AMENDMENT OF SOLICITATION

1. AMENDMENT/MODIFICATION NO. 0004		2. EFFECTIVE DATE MAY 07, 2003	
3. ISSUED BY DEPARTMENT OF THE ARMY, BALTIMORE DISTRICT CORPS OF ENGINEERS P.O. BOX 1715 BALTIMORE, MARYLAND 21203-1715

6. ACCOUNTING AND APPROPRIATION DATA (If required) LUKE C. MOORE SENIOR HIGH SCHOOL WASHINGTON, D.C.			
7. DESCRIPTION OF AMENDMENT/MODIFICATION (Organized by UCF section headings, including solicitation/contract subject matter where feasible.) <p style="text-align: center;"><u>SEE THE FOLLOWING PAGES</u></p>			
Except as provided herein, all terms and conditions of the document referenced in Item 4A, as heretofore changed, remains unchanged and in full force.

AMENDMENT NO. 0004 TO ADVERTISED RFP DACW31-03-R-0008
EFFECTIVE: MAY 07, 2003

SHEET: ED1.3

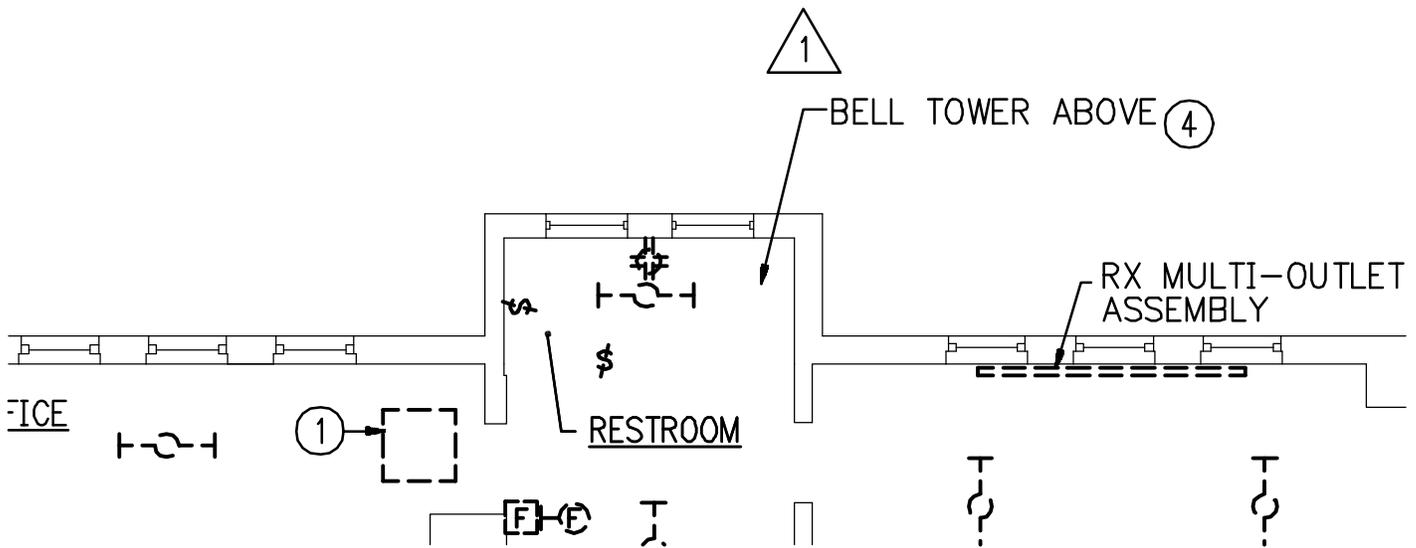
22) Sheet ED1.3: Revise this sheet in accordance with the attached Sketch SK-E-1, dated 5/05/03.

- ① ACCESS TO ATTIC. REMOVE WIRING IN ATTIC UNLESS OTHERWISE NOTED. △ 1
- ② REMOVE EXISTING INTERCOM DEVICES AND WIRING BACK TO SOURCE.
- ③ REMOVE EXISTING BELL TOWER MUSIC SYNTHESIZER. SAVE FOR REUSE. REMOVE SOUND WIRING BACK TO BELL TOWER AND SAVE FOR REUSE. △ 1
- ④ PROTECT BELL TOWER SOUND SYSTEM DURING CONSTRUCTION.

SHEET: E1.3

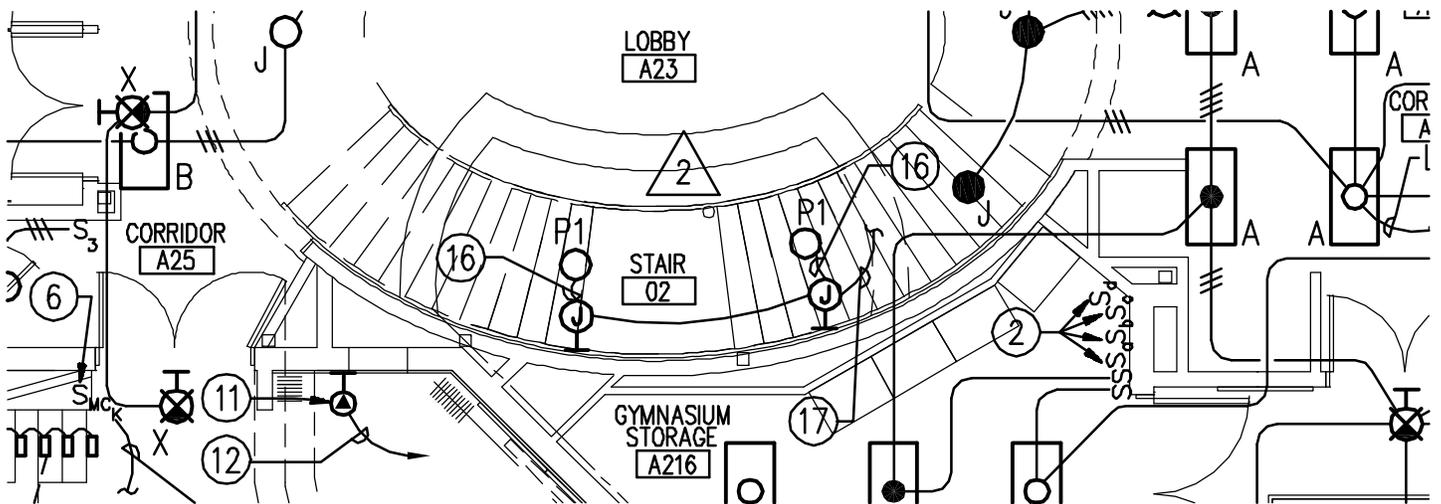
23) Sheet E1.3: Revise this sheet in accordance with the attached Sketch SK-E-2, dated 5/05/03.

△ 2 B. WORK ASSOCIATED WITH TYPE P1 LIGHT FIXTURES IS INCLUDED IN "FOUNTAIN WITH NATURAL STONE FACING" OPTIONAL BID ITEM.

①6 CONNECT TO JUNCTION BOX VIA SUBMERSIBLE CORD INCLUDED WITH LIGHT FIXTURE. SEE DETAIL

①7 SEE E2.3 FOR CONTINUATION.

SHEET: E2.2

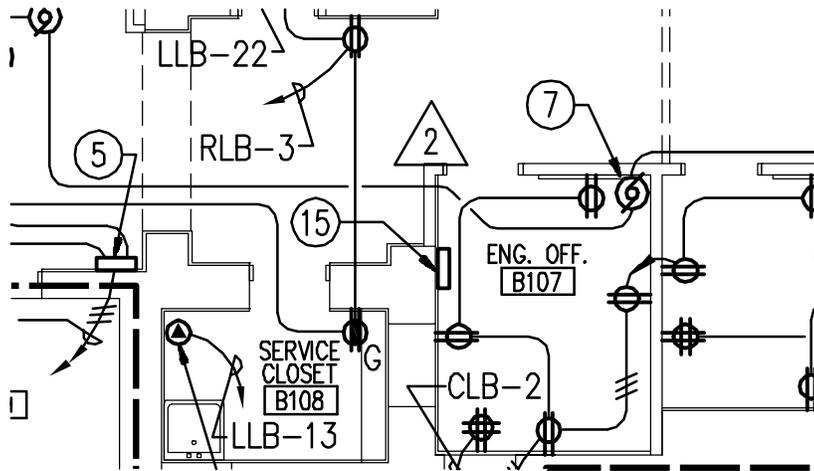
24) Sheet E2.2: Revise this sheet in accordance with the attached Sketch SK-E-3, dated 5/05/03.

⑭ COMBINATION NEMA SIZE 1 MOTOR STARTER/30A FUSED DISCONNECT. PROVIDE FUSES PER EQUIPMENT NAMEPLATE.

△ ⑮ GENERATOR REMOTE ALARM PANEL. SURFACE MOUNT 5'-0" ABOVE FLOOR. PROVIDE 1" CONDUIT AND WIRING AS REQUIRED TO ORIGINAL LOCATION OF PANEL, IN ROOM B101. SPLICE CONDUCTORS TO EXISTING CONDUCTORS IN JUNCTION BOX AS REQUIRED FOR PANEL OPERATION.

SHEET: E2.3

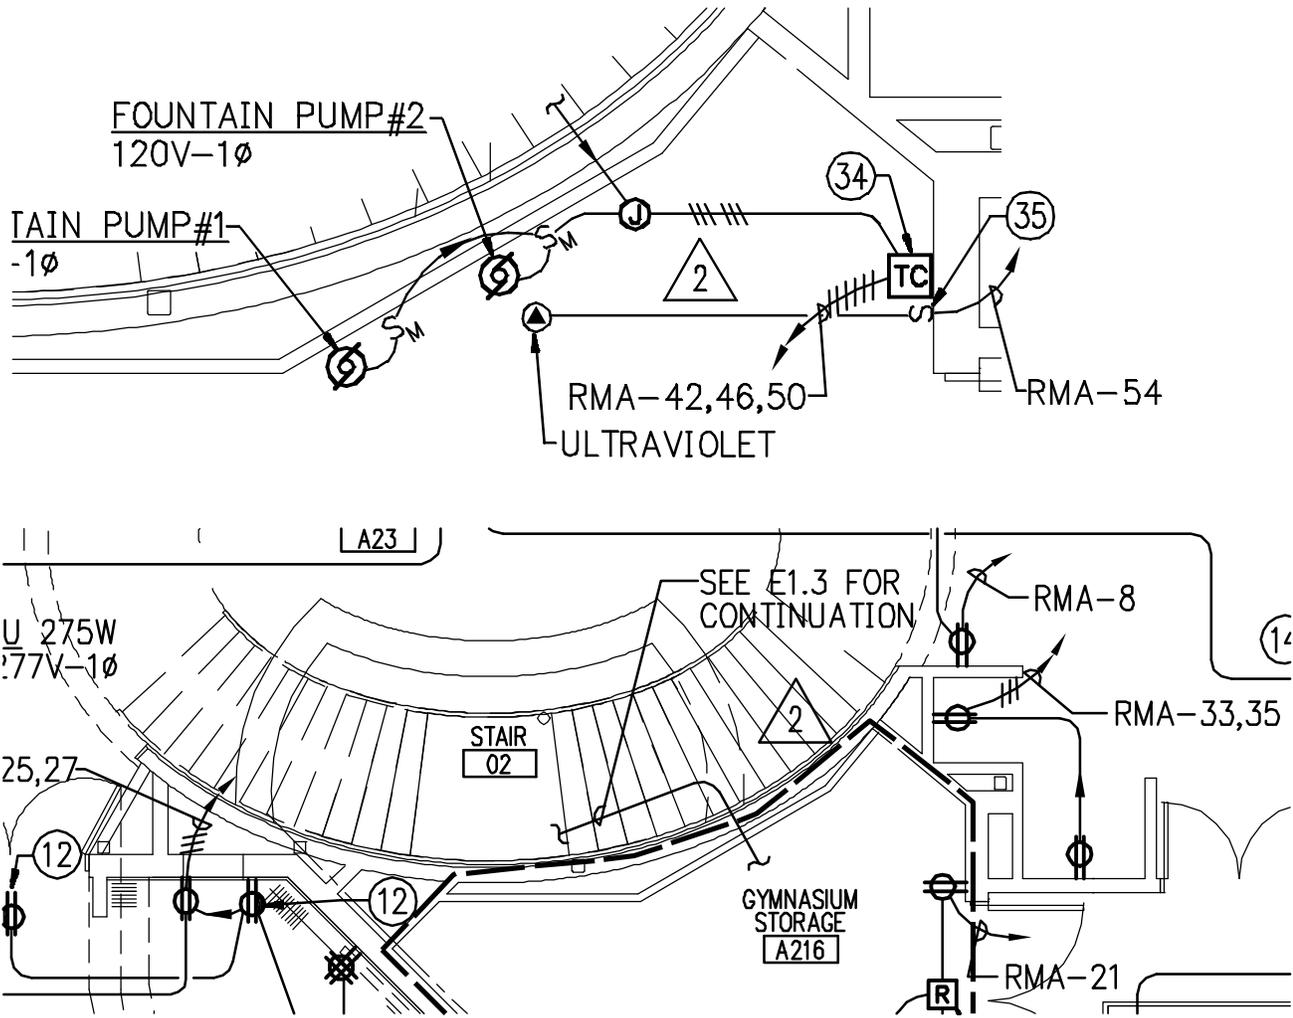
25) Sheet E2.3: Revise this sheet in accordance with the attached Sketch SK-E-4 dated 5/05/03

③4 PROVIDE 7-DAY TYPE TIME SWITCH, WITH SELF-STARTING SYNCHRONOUS MOTOR, CAPABLE OF BEING SET FOR DIFFERENT ON-OFF TIMES EACH DAY OF THE WEEK. TIME SWITCH CONTACTS SHALL BE CAPABLE OF SWITCHING 40 AMPS CONTINUOUSLY AT 120 VOLTS AND SHALL BE FOUR-POLE SINGLE-THROW. MOUNT 44" ABOVE FLOOR. LABEL "FOUNTAIN TIMER".

SHEET: E2.6

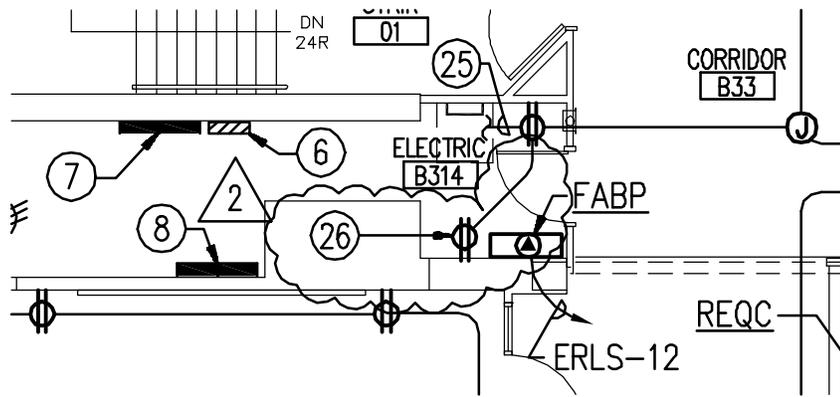
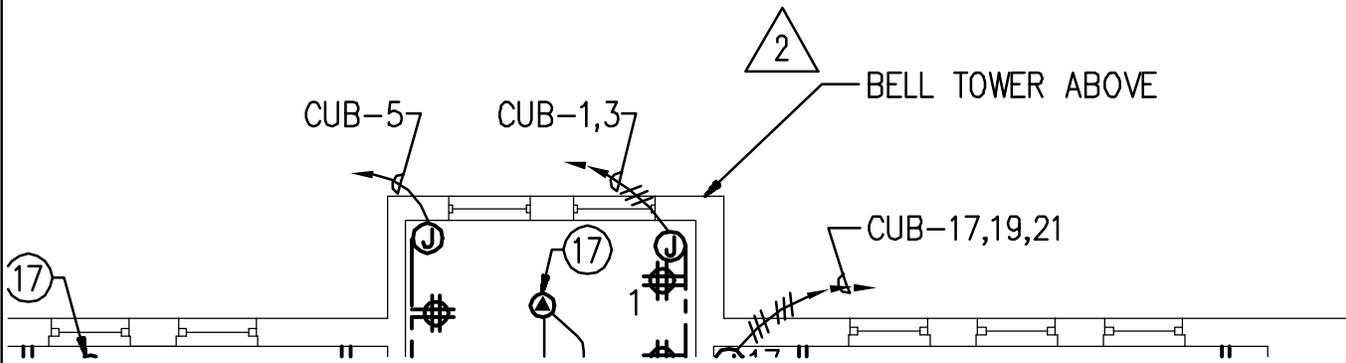
26) Sheet E2.6: Revise this sheet in accordance with the attached Sketch SK-E-5 dated 5/05/03.

②④ FASTEN RECEPTACLE SECURELY TO CEILING PIPE GRID. (TYPICAL OF 4)

②⑤ PROVIDE DUPLEX GROUND FAULT CIRCUIT INTERRUPTION RECEPTACLE IN ATTIC ADJACENT TO HATCH. PROVIDE SECOND DUPLEX GROUND FAULT CIRCUIT INTERRUPTER RECEPTACLE BY EXISTING TO REMAIN BELL TOWER SOUND SYSTEM.

SHEET: E3.3

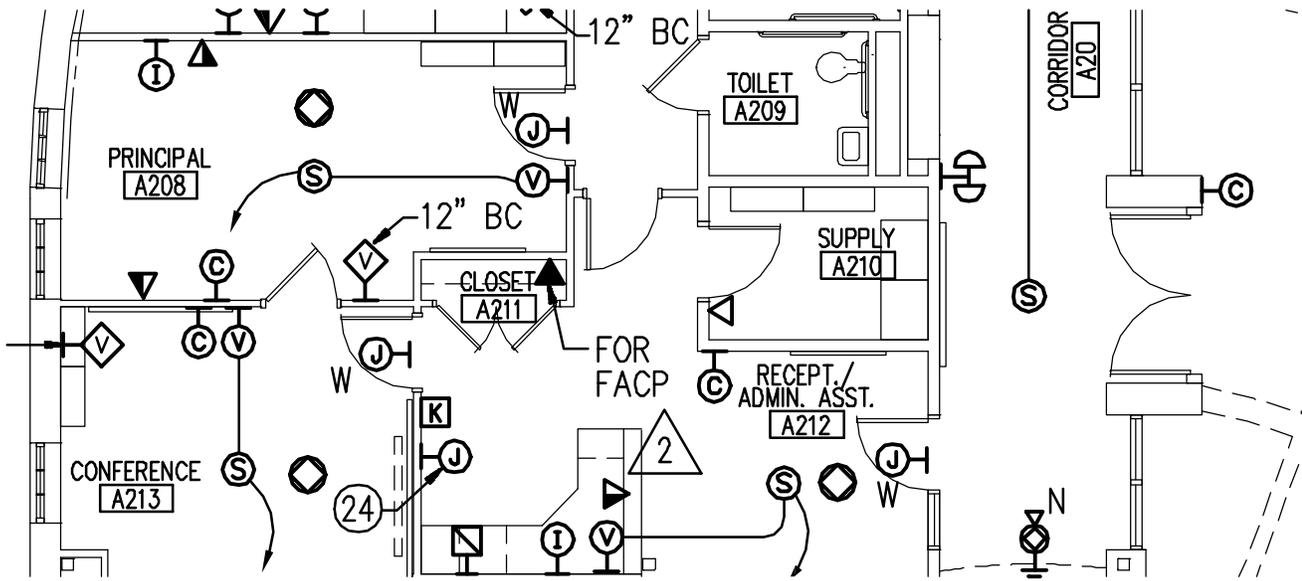
27) Sheet E3.3: Revise this sheet in accordance with the attached Sketch SK-E-6 dated 5/05/03.

SHEET: E3.6

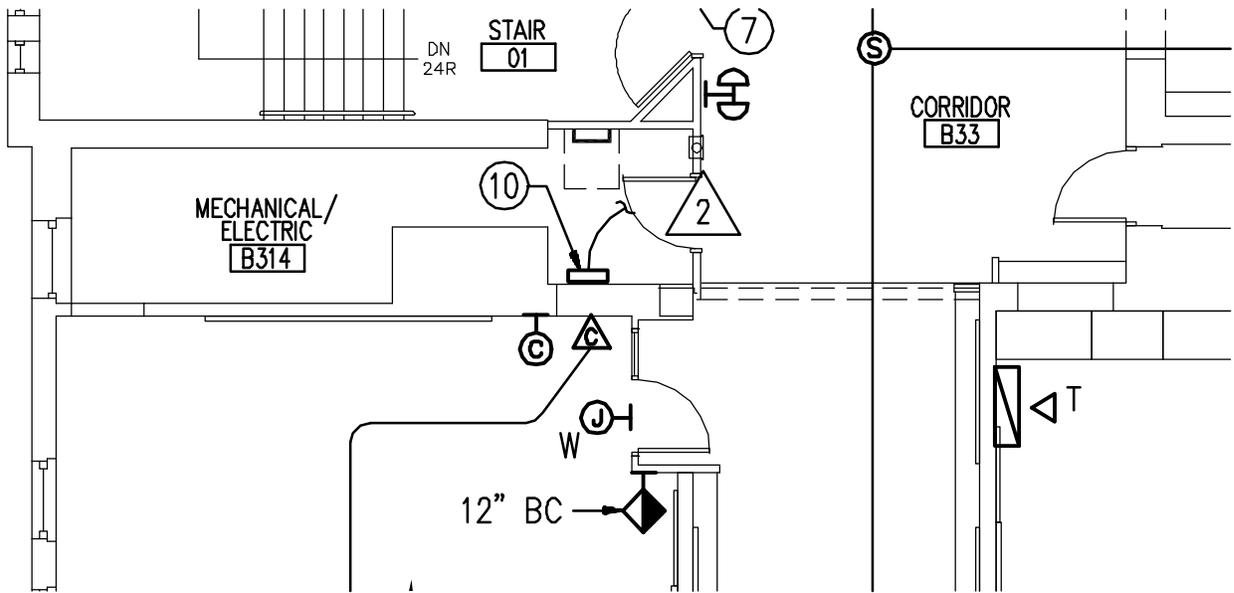
28) Sheet E3.6: Revise this sheet in accordance with the attached Sketch SK-E-7 dated 5/05/03.

⑨ SET APERTURE TO F2.5

⑩ INSTALL PREVIOUSLY REMOVED BELL TOWER SOUND SYNTHESIZER. PROVIDE SHELF 4'-0" ABOVE FLOOR. REINSTALL CABLE FROM BELL TOWER SOUND SYSTEM TO SYNTHESIZER.

LUKE C. MOORE ACADEMY HIGH SCHOOL	DATE	AMENDMENT
SHEET: E4.1	05/05/03	# SK-E-8
SCALE: 1/8"=1'-0"

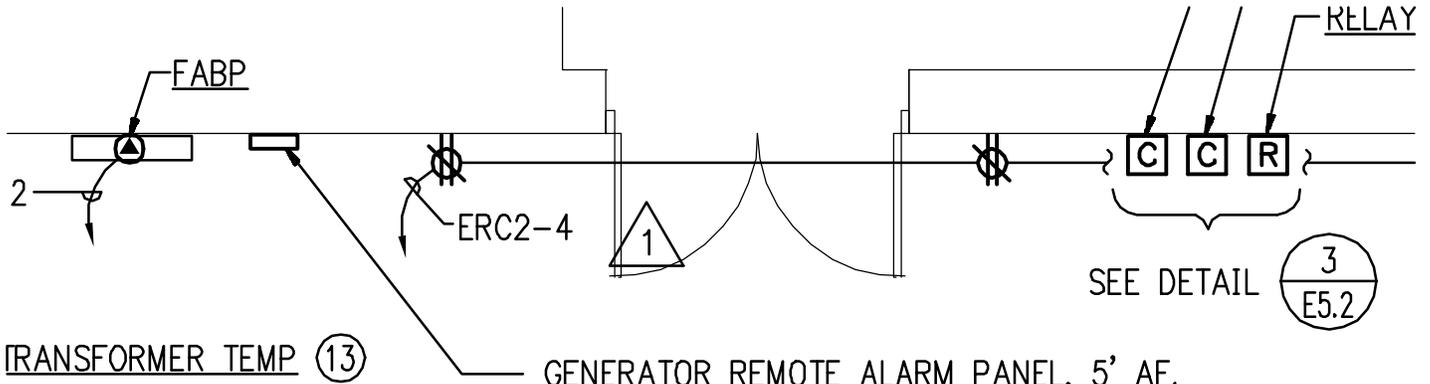
29) Sheet E4.1: Revise this sheet in accordance with the attached Sketch SK-E-8 dated 5/05/03

GENERATOR REMOTE ALARM PANEL, 5' AF.
 INSTALL UNDER PHASE 1 CONSTRUCTION.
 DURING PHASE 2 CONSTRUCTION, REMOVE
 PANEL AND REPLACE WITH JUNCTION BOX.
 REINSTALL PANEL IN ENGINEER OFFICE B107.
 SCHEDULE WORK SO THAT PANEL IS OUT OF
 SERVICE FOR LESS THAN 4 HOURS.

- ③ PROVIDE CAT 5E CABLE TO HEAD END ROOM A305 FOR ELEVATOR CAB PHONE – DEDICATED ANALOG PHONE LINE. △ 1
- ④ LOCKABLE "OFF" BUT NOT "ON".

SHEET: E5.6

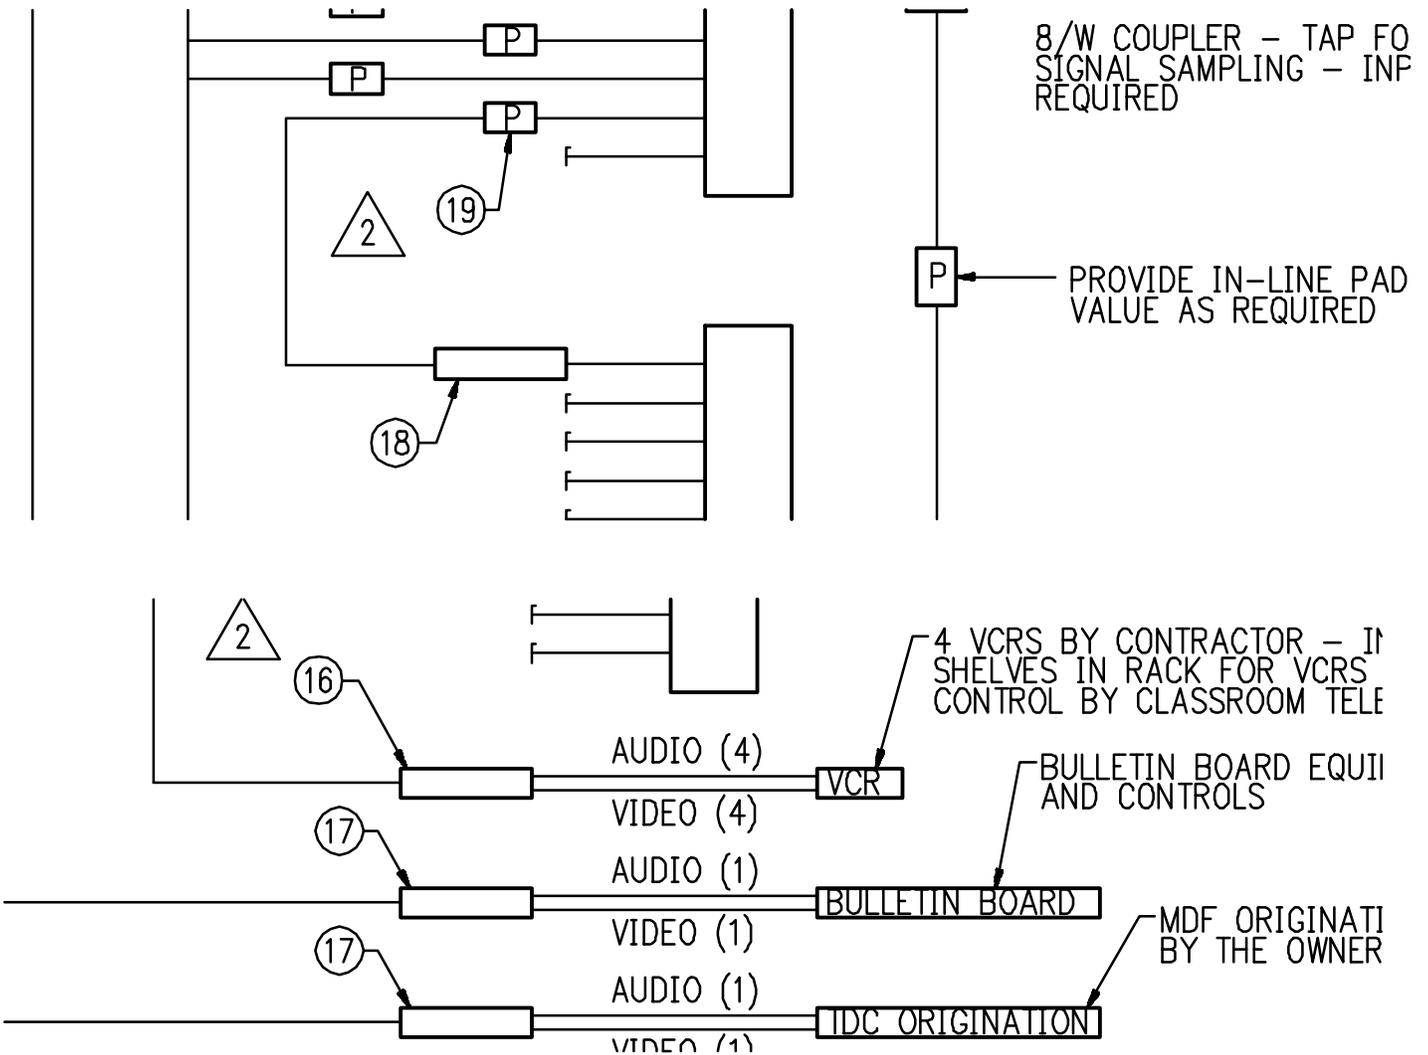
32) Sheet E5.6: Revise this sheet in accordance with the attached Sketch SK-E-9 dated 5/05/03.

- ⑩ PROVIDE 4 FREQUENCY AGILE MODULATORS. CORRECT SYSTEM DATA AND ADJUST.
- ⑪ PROVIDE 1 FREQUENCY AGILE MODULATORS. CORRECT SYSTEM DATA AND ADJUST.
- ⑫ PROVIDE CHANNEL 19 – AGILE OUTPUT PROCESSOR. CONNECT INTO SYSTEM AND ADJUST.
- ⑬ PROVIDE IN-LINE PADS AS REQUIRED TO EQUALIZE COMBINER INPUTS – TYPICAL.

SHEET: E6.2

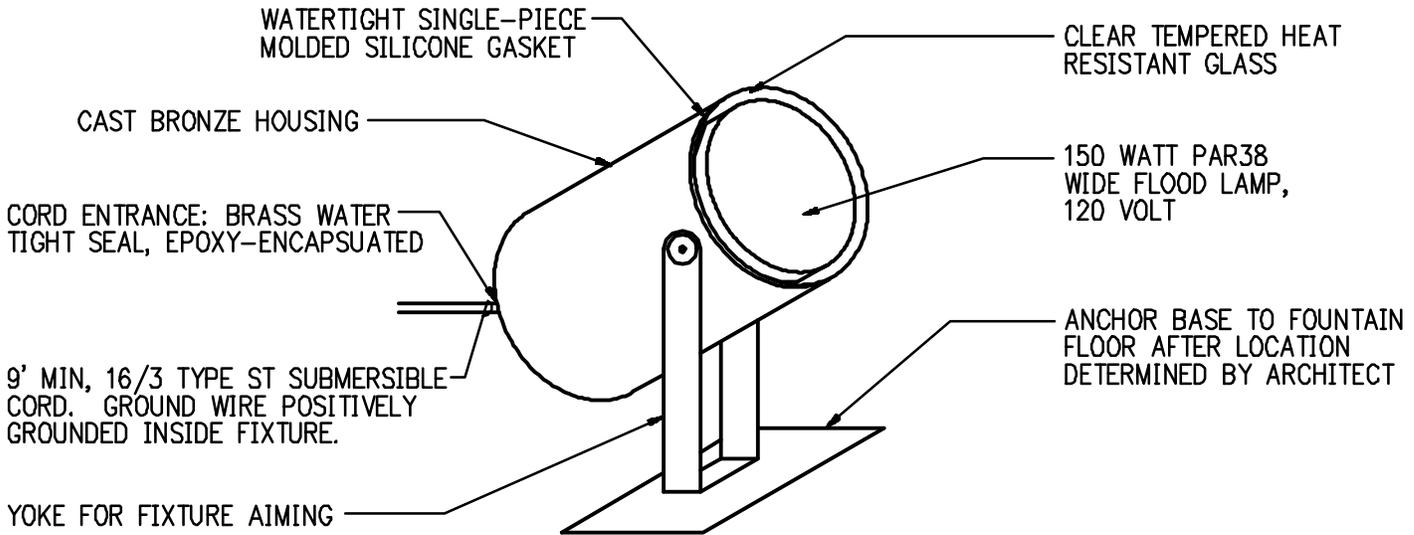
33) Sheet E6.2: Revise this sheet in accordance with the attached Sketches SK-E-10 and SK-E-11 dated 5/05/03.

16. PROVIDE UNDER OPTIONAL BID ITEM "FOUNTAIN WITH NATURAL STONE FACING".

SOCKET: PORCELAIN MEDIUM BASE WITH NICKEL-PLATED COPPER SHELL, 200°C INSULATED.

PROVIDE TEMPERATURE SENSOR TO DISCONNECT POWER TO LAMP WHEN WATER LEVEL IS TOO LOW TO PROVIDE COOLING.
